EASTERN COLORADO AGGREGATES, L.L.P.

Re: Midwestern Farms, Permit No. M-1993-059, Technical Revision No. 5, CPW Cancellation of Participation in project – Eastern Colorado Aggregates Response.

REQUEST FOR TECHNICAL REVISION (TR) COVER SHEET

EXHIBIT E-1 (REVISED 6:1 CROSS SECTION)

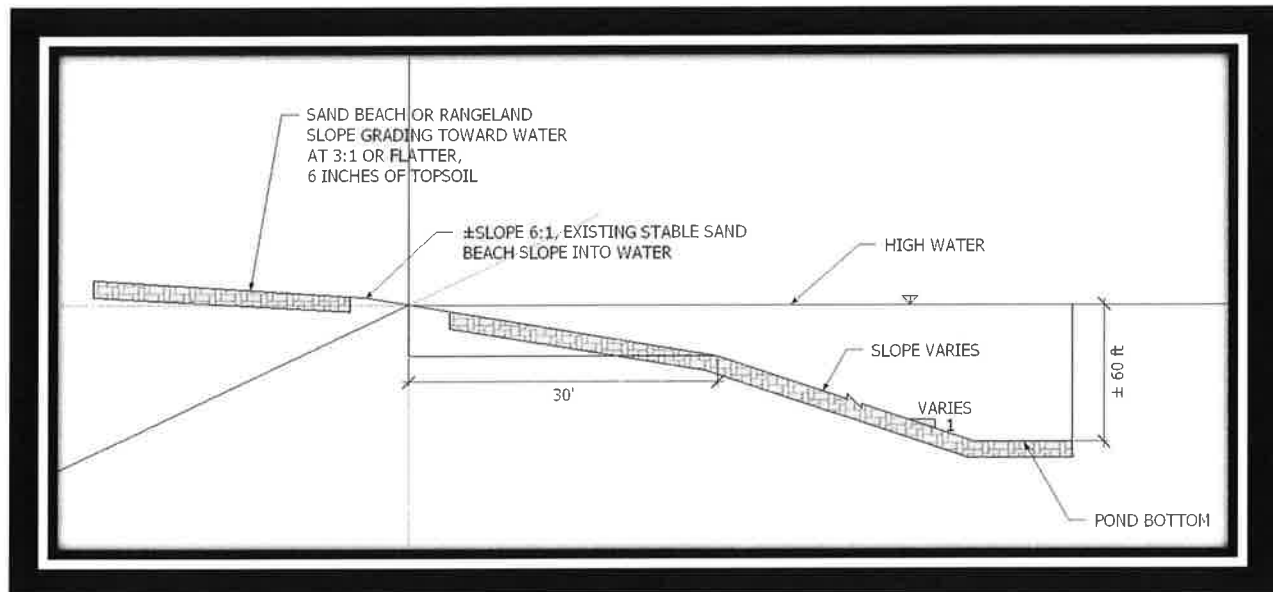
2. 97.1 acres, ~~except~~ by removing the material separating the two ponds as described below and creating one pond."
3. **Pond Slopes** - Pond slopes will be reclaimed per the attached Exhibit E-1, E-2, and Exhibit F – Reclamation Plan Map.

- a. How does the operator intend to achieve these slope gradients below the water line? - The ponds will be will be excavated to the approved sections below the water line.

- d. Please see our revised Exhibits E-1, E-2 cross sections and Exhibit F – Reclamation Plan Map which show the reclaimed shore line details.
4. **49.2 acre Industrial / Commercial post reclamation land use** – Please see the attached notarized letter from Mid-Western Farms which agrees to retain the 49.2 acre plant site in its current un-reclaimed condition for post mining industrial / commercial uses.

EXHIBIT E-2 (REVISED 3:1 CROSS SECTION)

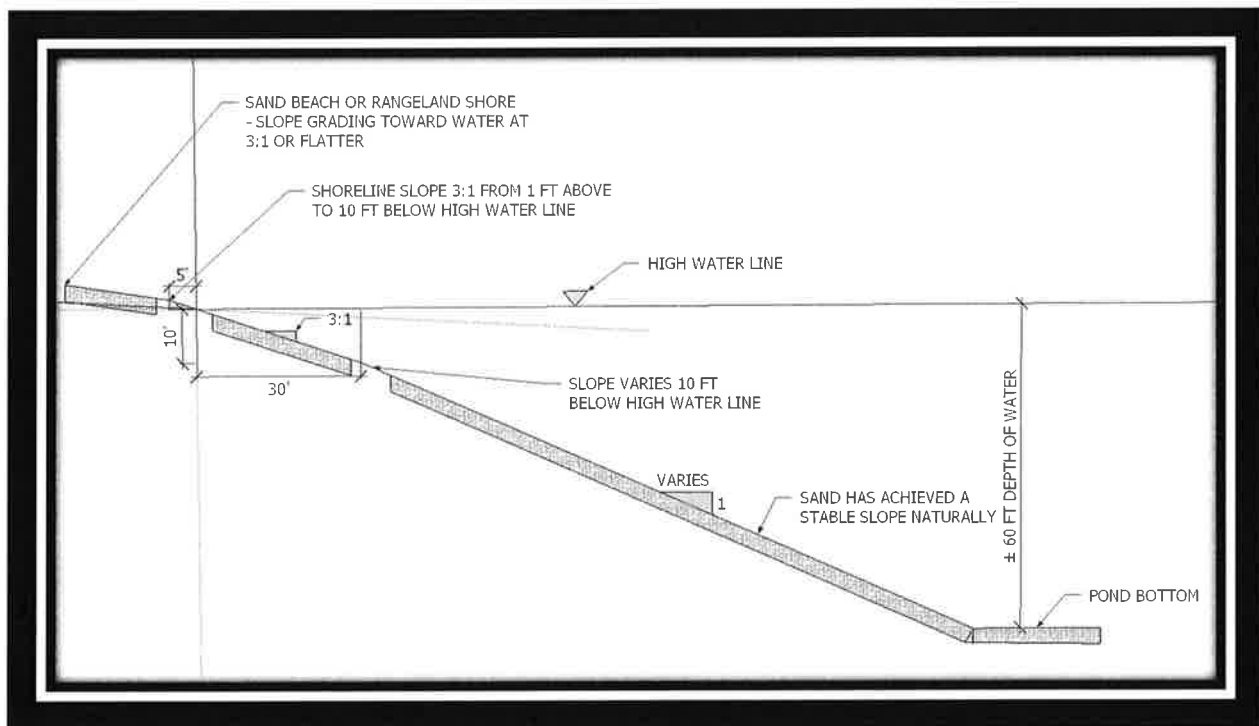
23. Please disregard this statement “Disturbed outer edges 50 acres”. Please refer to revised Exhibit F – Reclamation Plan Map and Revised Exhibit L – Reclamation Cost for clarification of the existing disturbed areas, top soil borrow area and the eastern shore back slope area.
24. Refer to Exhibit E – Reclamation Plan revised cross sections E-1, E-2 and Exhibit F Reclamation Plan Map. The CPW has requested specific sections of pond shoreline to be left in their current condition. All other shoreline to be graded at 3:1 cross sections on the east side of the east pond area.

Exhibit F

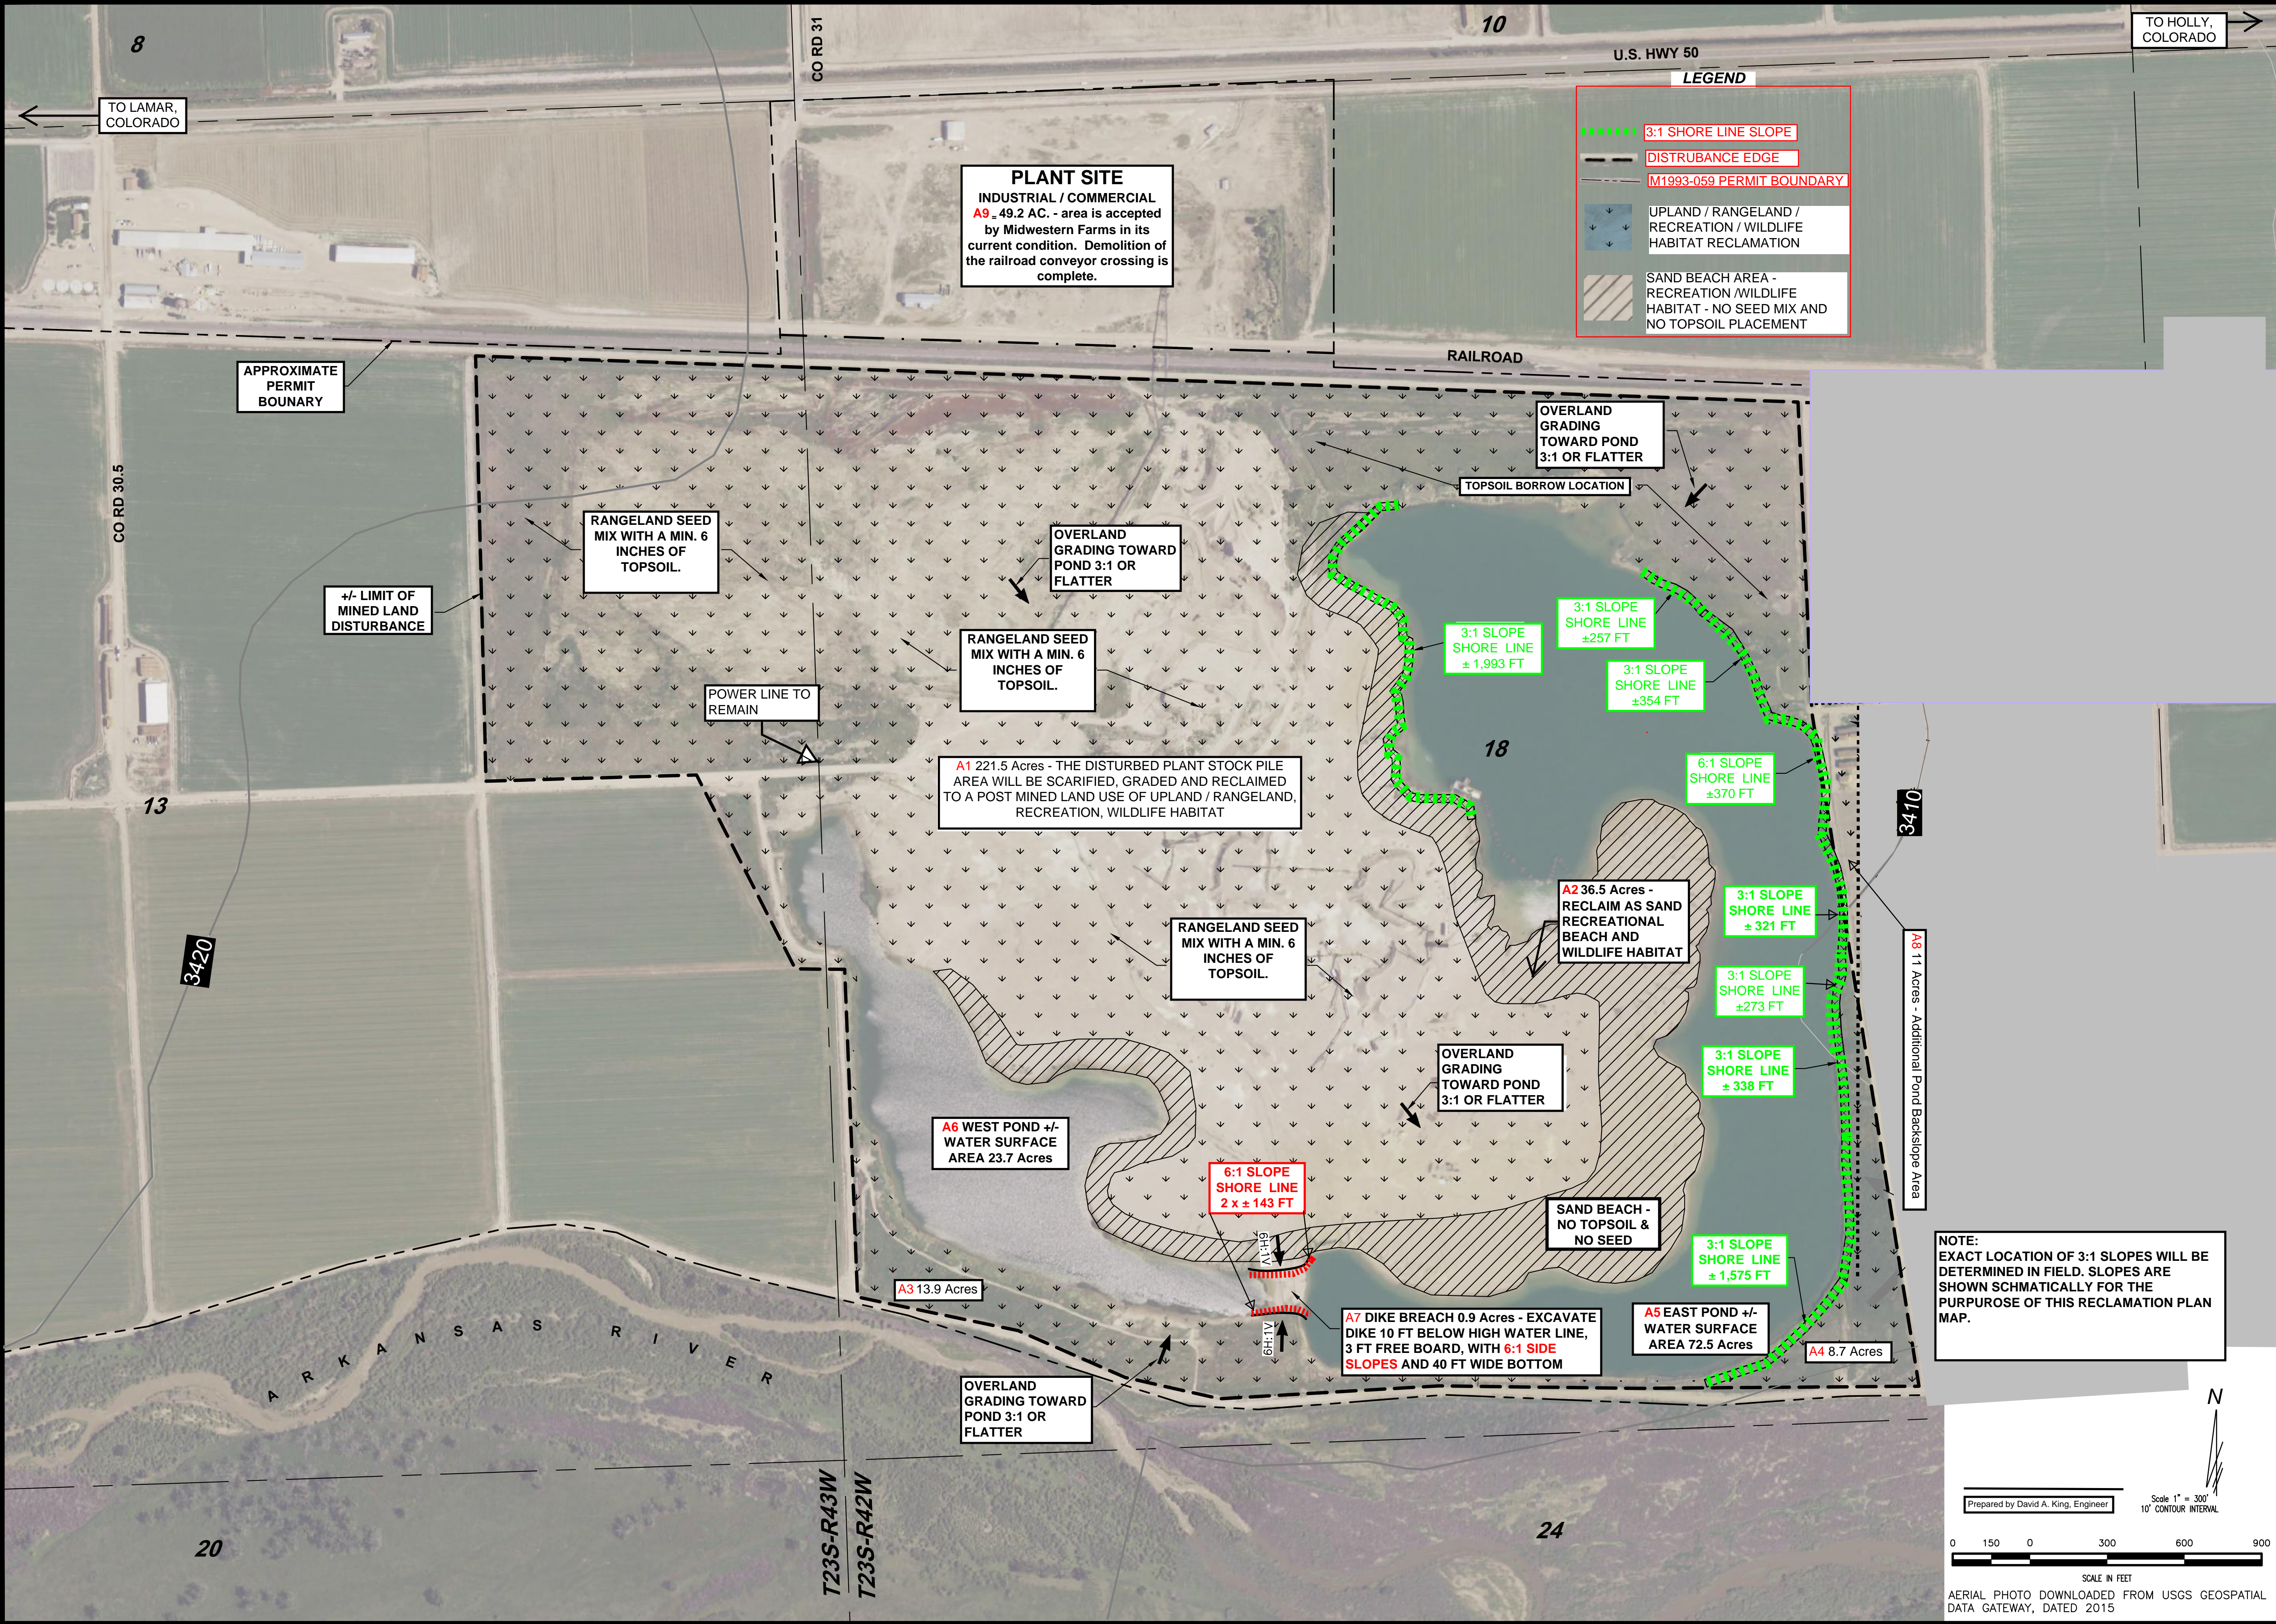
- b. Existing topsoil storage area will have a minimum of 6 inches topsoil after excavation.
8. **Exhibit F – Reclamation Plan Map** - Please see the revised and legible copy of the Exhibit F – Reclamation Plan Map.

9. **Technical Revision Cover** - Please see the revised Technical Revision Cover Sheet to include range land and recreation in the description.
 - a. Exhibit F – Reclamation Plan Map includes descriptions of the final land use of the affected lands.

- The current disturbed area with the industrial/commercial area = 426.9 acre, which is less than the 439.2 acres. The additional land is for the east side pond back slope area. Please refer to Exhibit F – Reclamation Plan Map and the following table.

16. Please see the revised and legible Exhibit F – Reclamation Plan Map.
17. Revise Exhibit L – Reclamation Cost with a statement, “The conveyor belt across the Burlington Northern Railroad tracks has been removed as of this date.” The conveyor crossing the railroad tracks has been demolished. The conveyor parts and equipment will be removed from the disturbed area south of the railroad and all associated costs of the removal have deleted from the reclamation costs.
